**Origination Form**  
 Proposed Revisions to a Standard Plans Index

<b>Originator:</b>	Gibbs, Shae	<b>Index Number:</b>	711-003
<b>Date:</b>	5/5/2025	<b>Sheet Number(s):</b>	2,5,6,7
<b>E-mail:</b>	shae.gibbs@dot.state.fl.us	<b>Index Title:</b>	Interchange Markings

**Summary of the changes:**

TYPICAL CURVED EXIT RAMP

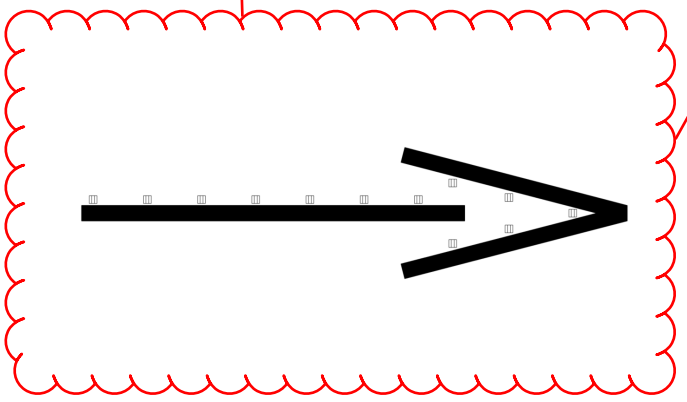
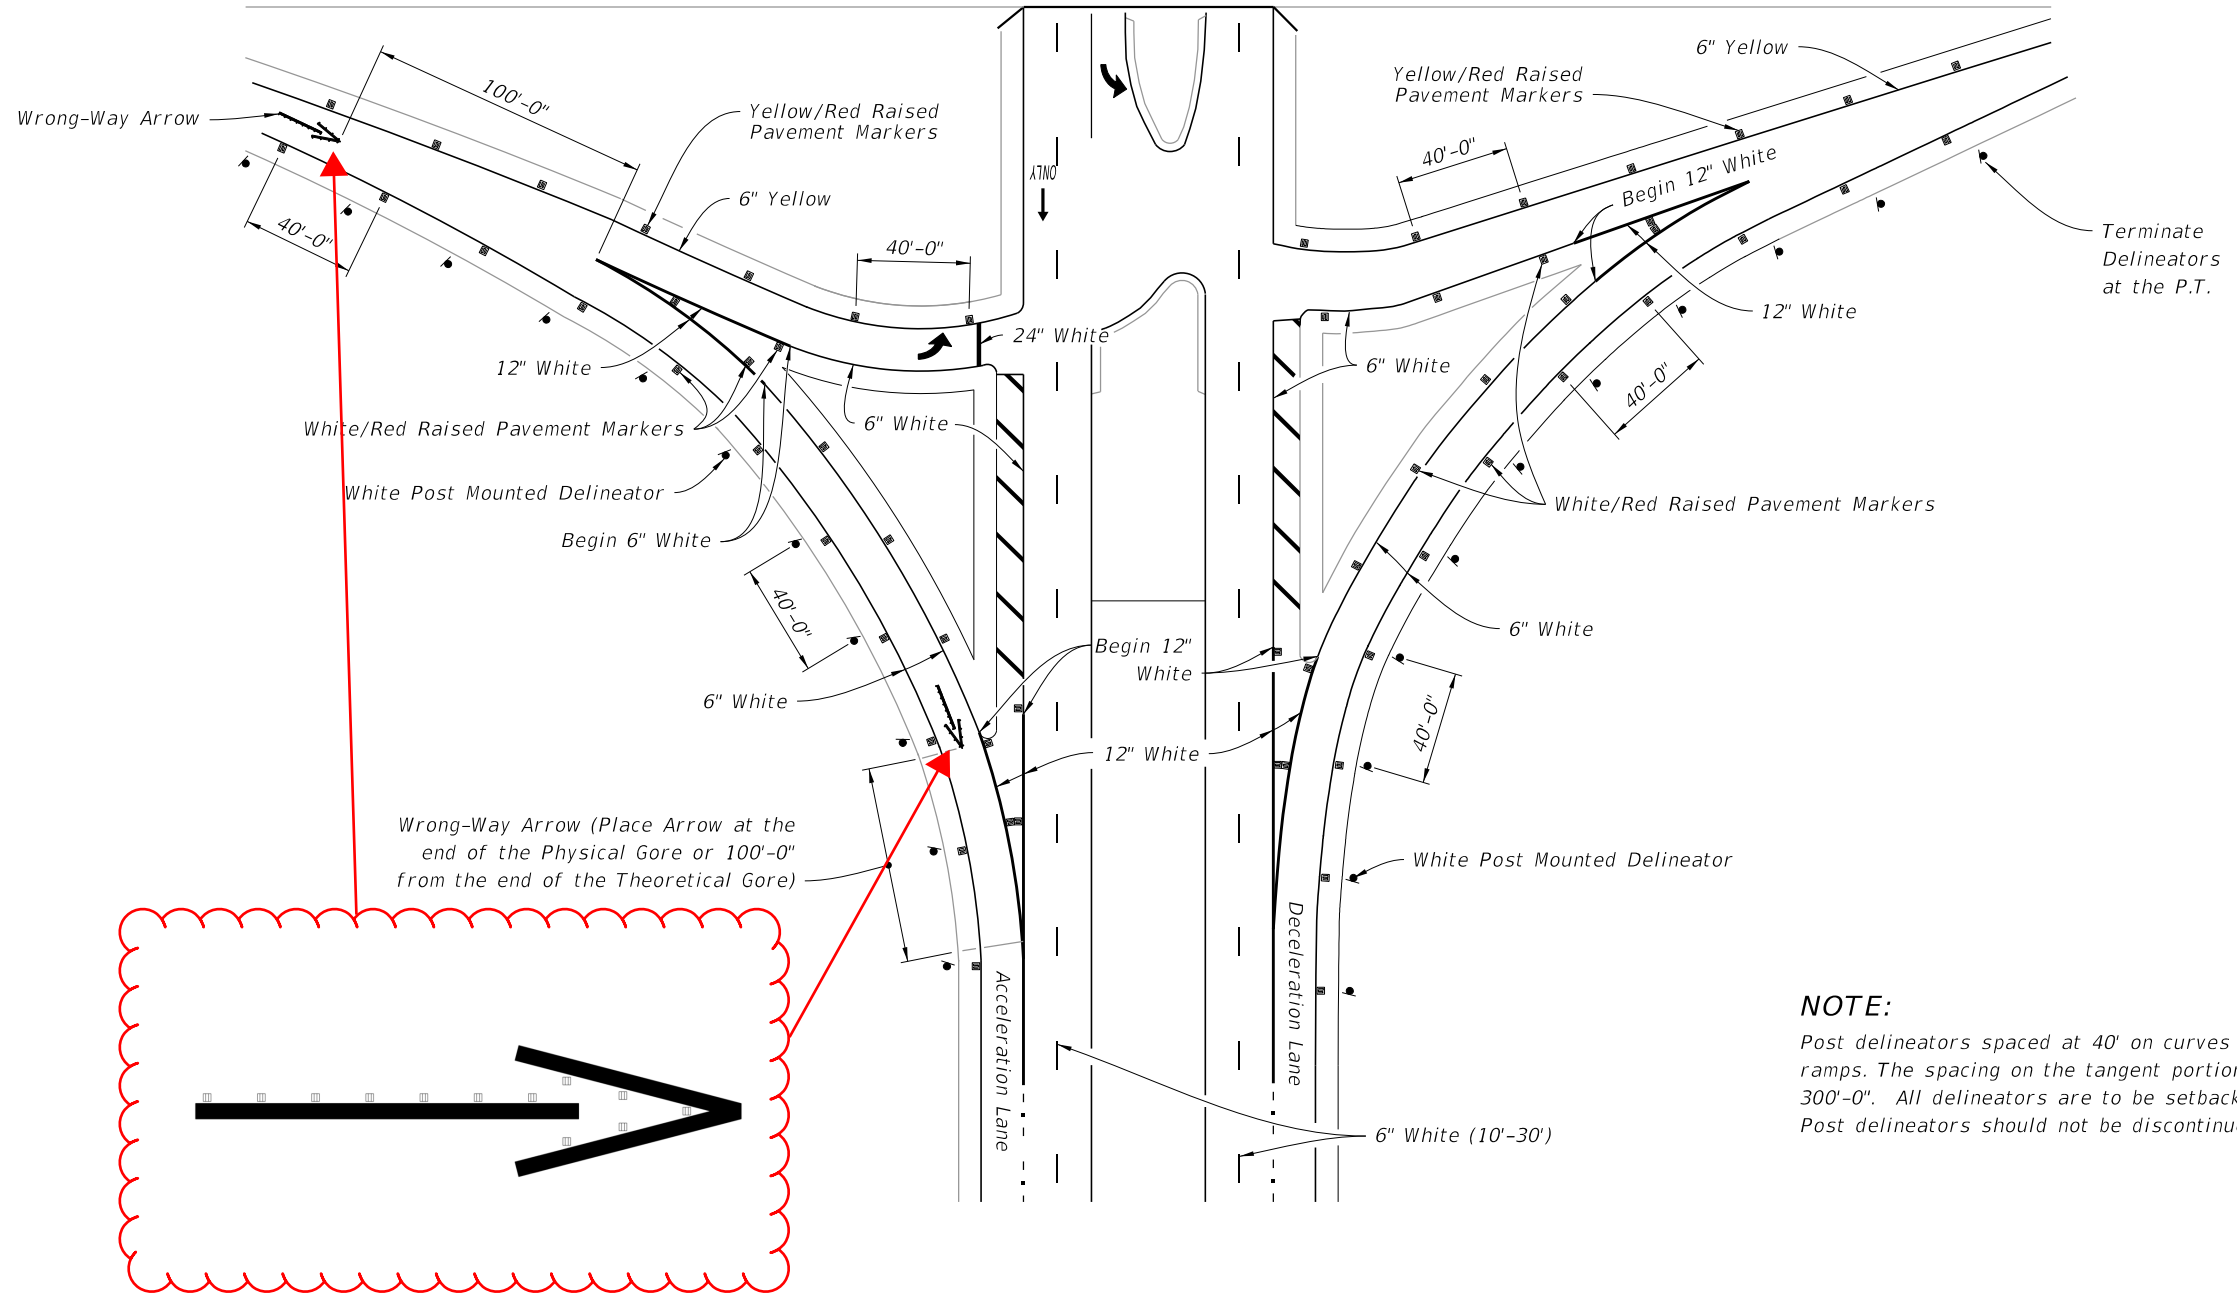
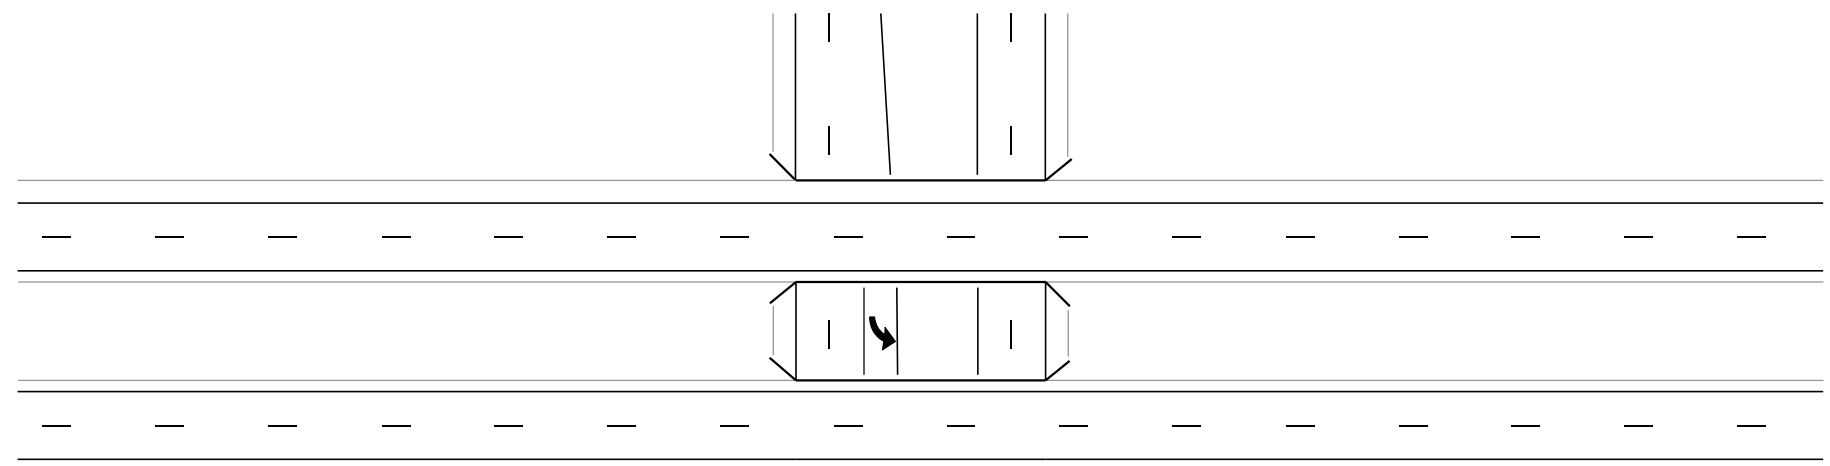
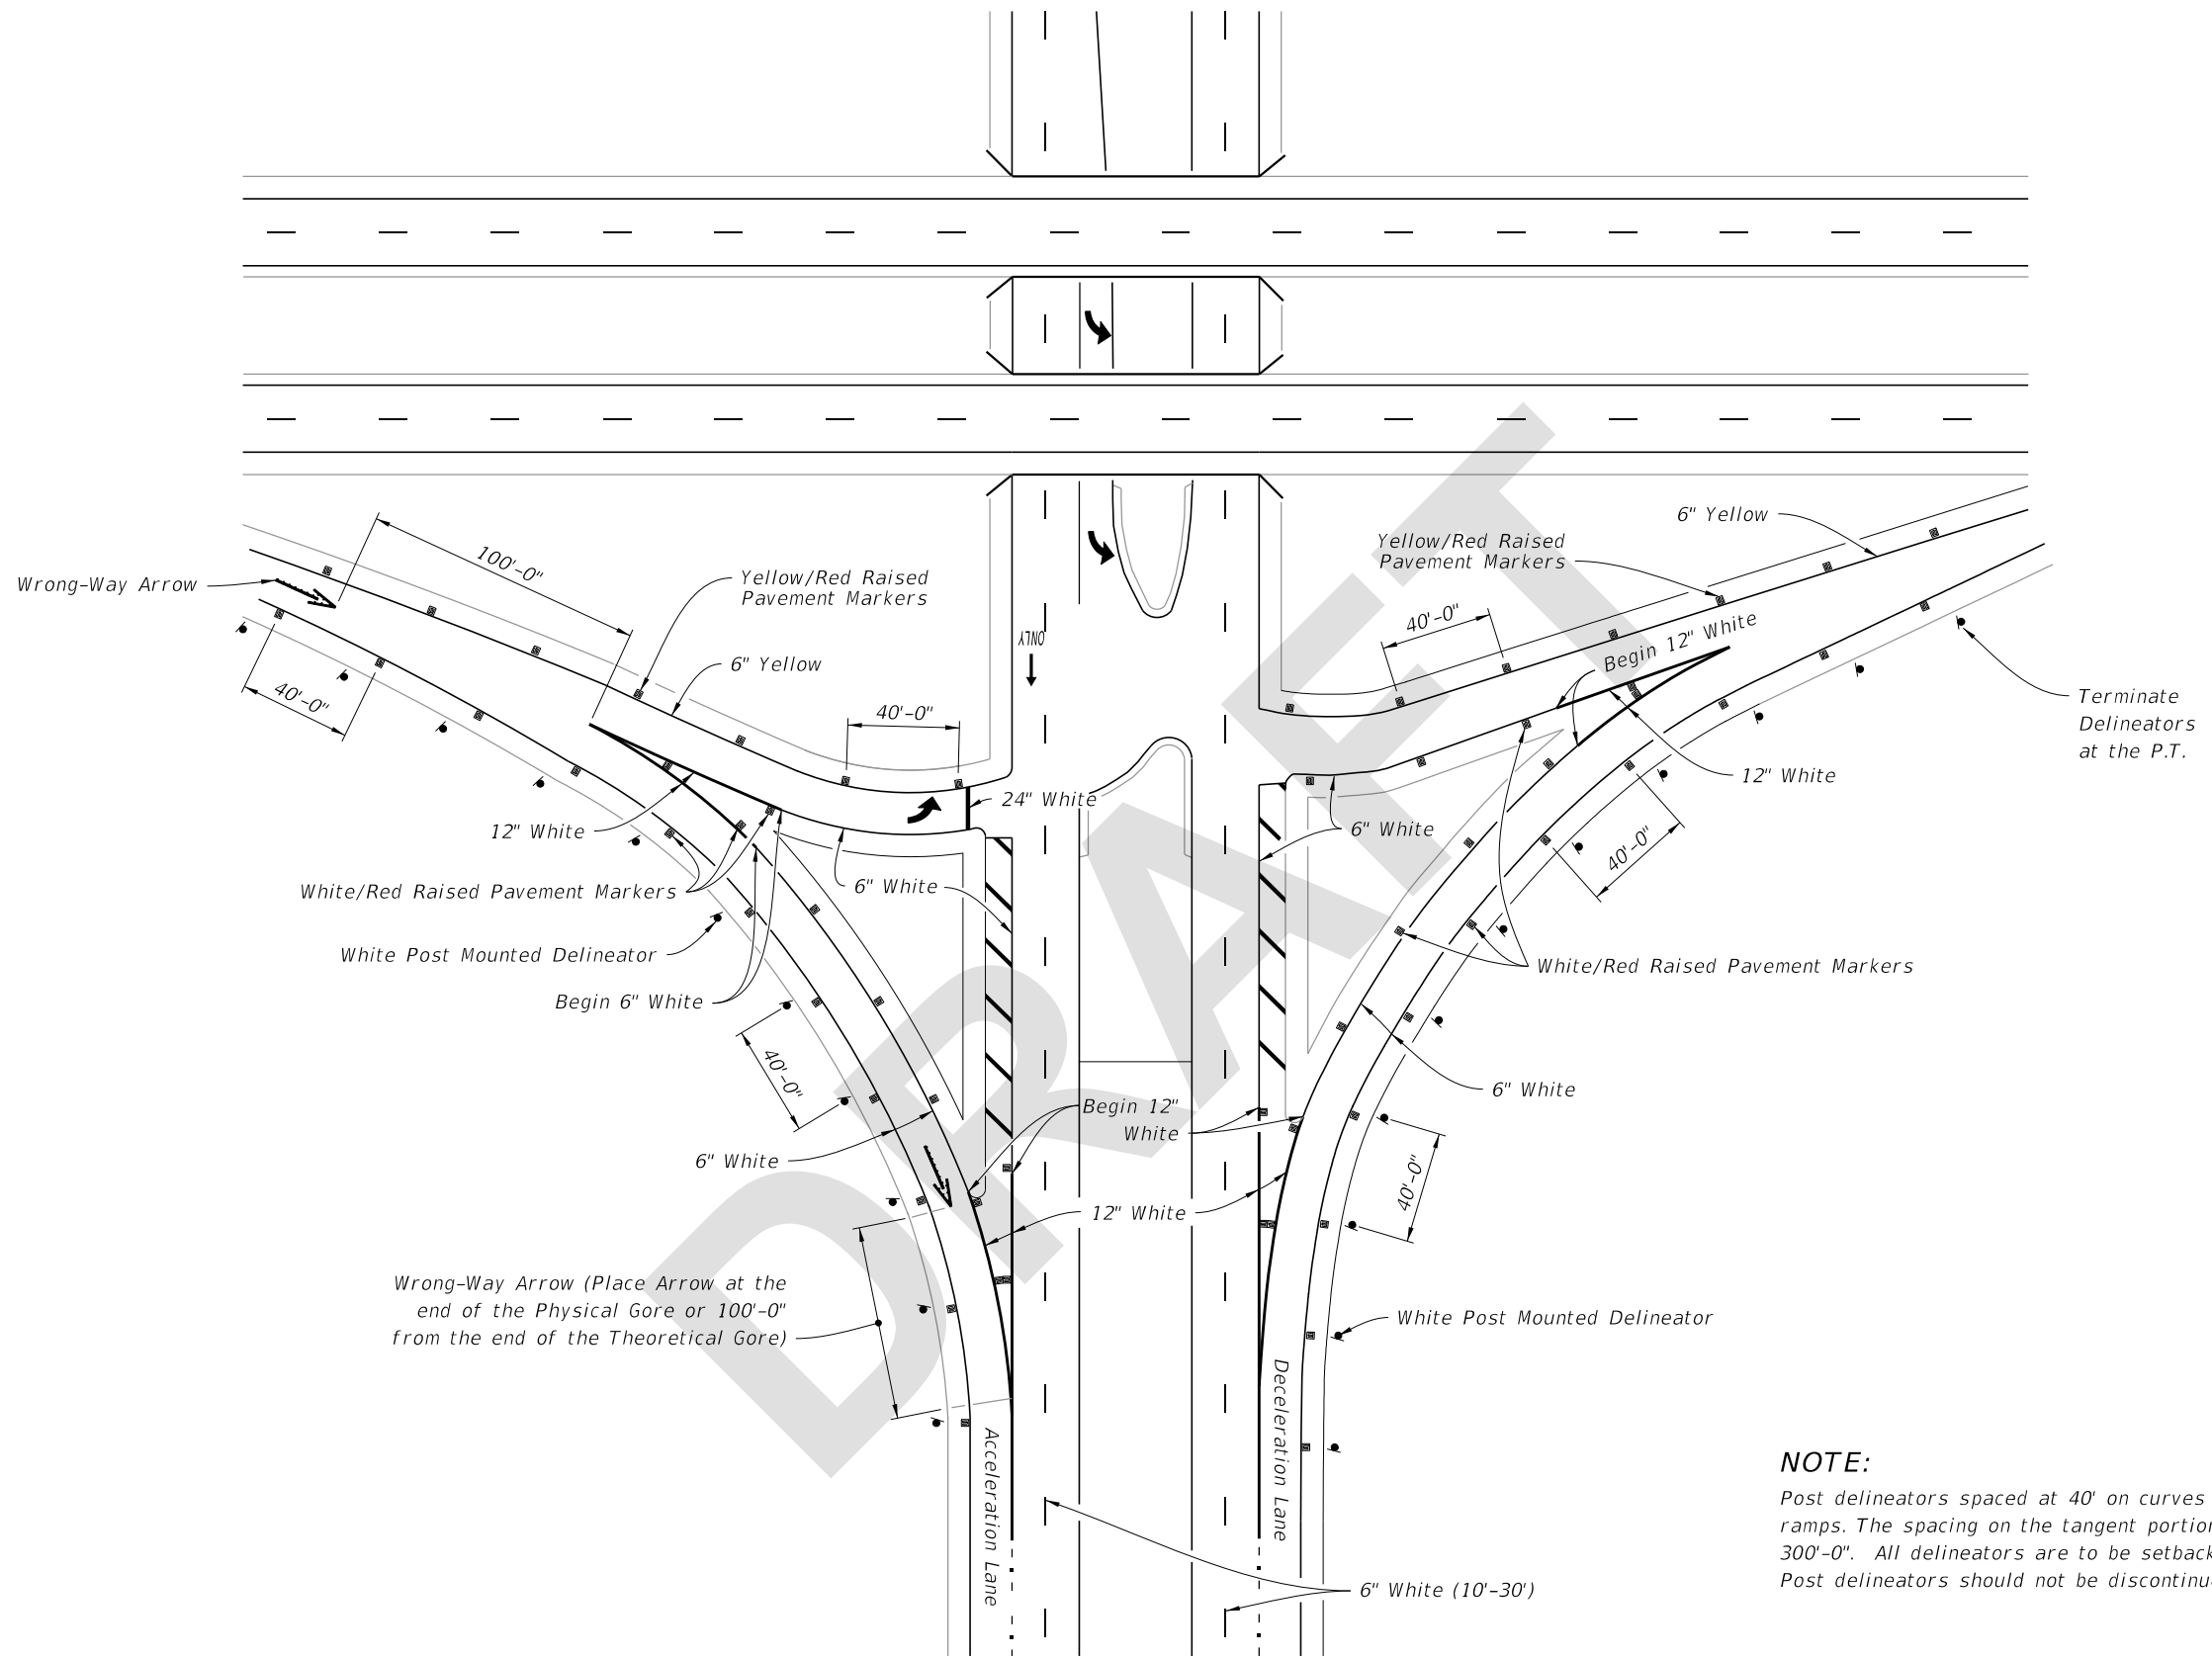
Sheets 5, 6, and 7: Update WWD Arrows to match proposed revision to 706-001

UPDATED Wrong Way Arrows to remove extra RPMs per 706-001 revision
